File 1993-0145

Name: Country Club Estates- Major sub.-Prelim. = SE Corner of G Rd./27 Rd.

REVIEW COMMENTS

TITLE HEADING: Preliminary Plan - Country Club Estates

TURN AROUND DETAIL

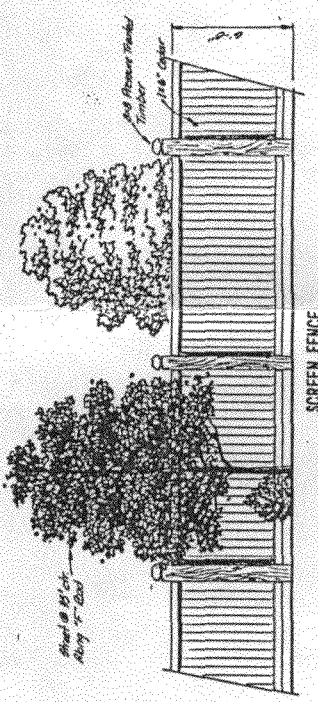
1. Preliminary drainage report look OK.
2. Site Plan - a copy of the turnaround with a single-unit vehicle turning on it is attached. This design will be very difficult for fire trucks, garbage trucks and street sweepers - impossible if parking is allowed on the street.
3. Westcliff Drive - based on code requirements, developer is responsible for half-street improvements, and providing a turn-around unless the street plans for the subdivision are revisited.

1. The cul-de-sac design does not provide for adequate turnaround space for our emergency vehicles. This must be re-designed to meet City standards.
2. The fire hydrants will have to be repositioned when the cul-de-sac's are re-designed. Fire hydrants are to be positioned at each intersection and spaced no greater than 500 feet apart, so that no property is greater than 250 feet from a fire hydrant.
3. Re-submit your revised plans for our review.

1. Attached is a drawing (EXHIBIT I) which illustrates the turning radius requirements for a single unit vehicle with a 30 foot wheel base. EXHIBIT I utilizes Figure II-2 from AASHTO'S, *Geometric Design of Highways and Streets, Design Controls and Criteria*. The landscaped median introduces a "human scale" to the development, as well as, reducing adverse environmental impacts created when large expanses of pavement are introduced into a residential setting. EXHIBIT II illustrates the conventional turn around approach as suggested by staff. It is the petitioner's desire to maintain the landscaped turn around. However, if it is the Planning Commission's desire to utilize the traditional turn around the plan will be modified for the Final Plat and Plan review process.

FIG. ONE

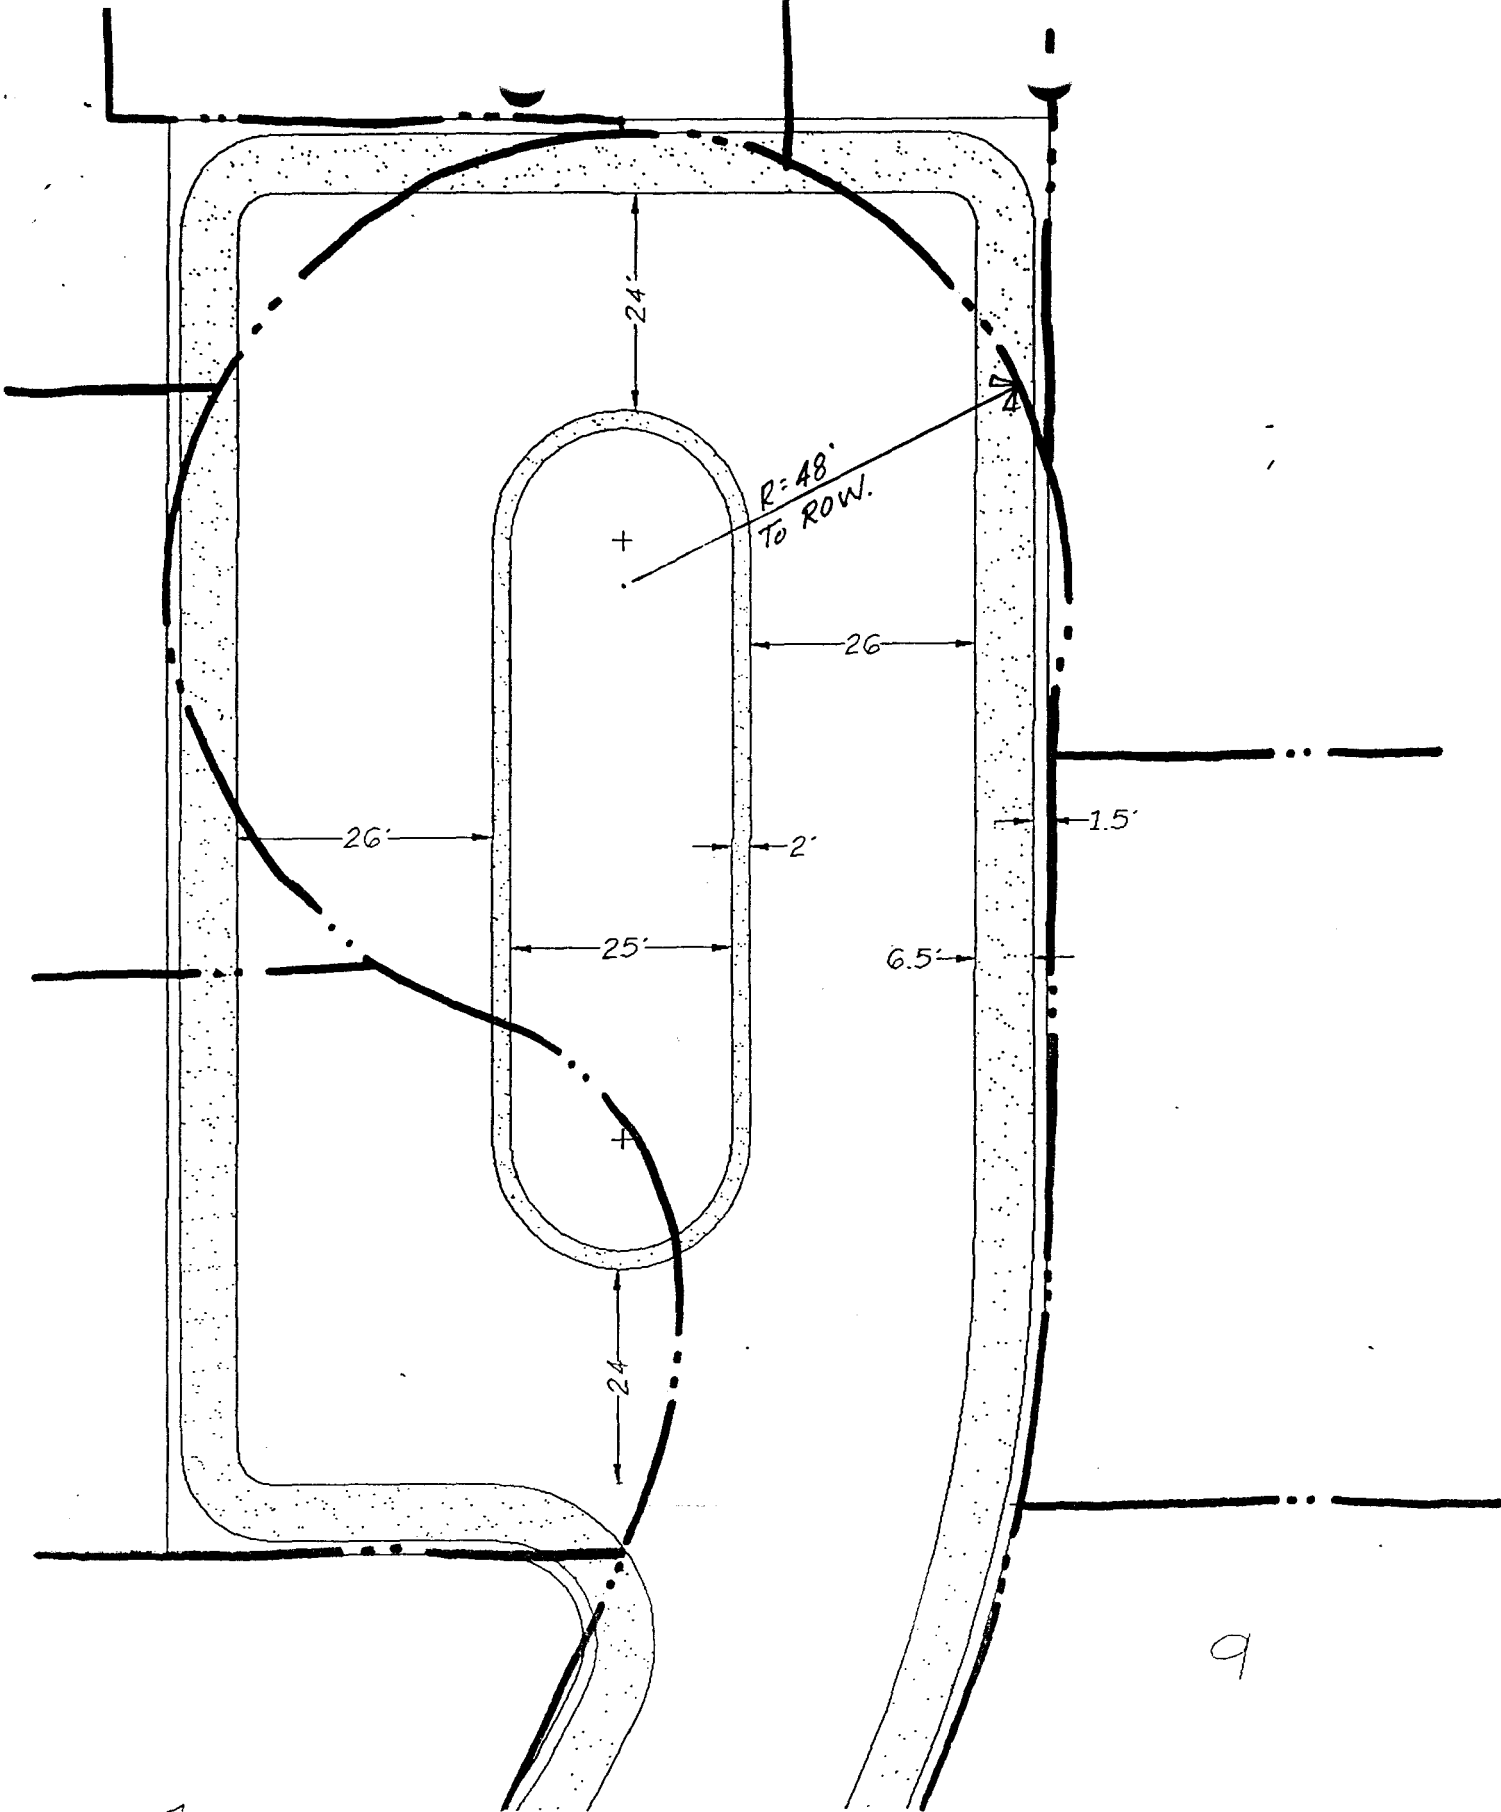
In response to staff comments, the petitioner has provided two design options for the proposed cul-de-sacs within the development. The rectangular shaped design with the landscaped median as originally proposed does not provide adequate turning radii and creates problems for street sweeping. A more standard designed cul-de-sac should be required. The redesigned cul-de-sacs will require repositioning of fire hydrants. Fire hydrants are to be positioned at each intersection and spaced no greater than 500 feet apart, so that no property is greater than 250 feet from a fire hydrant.
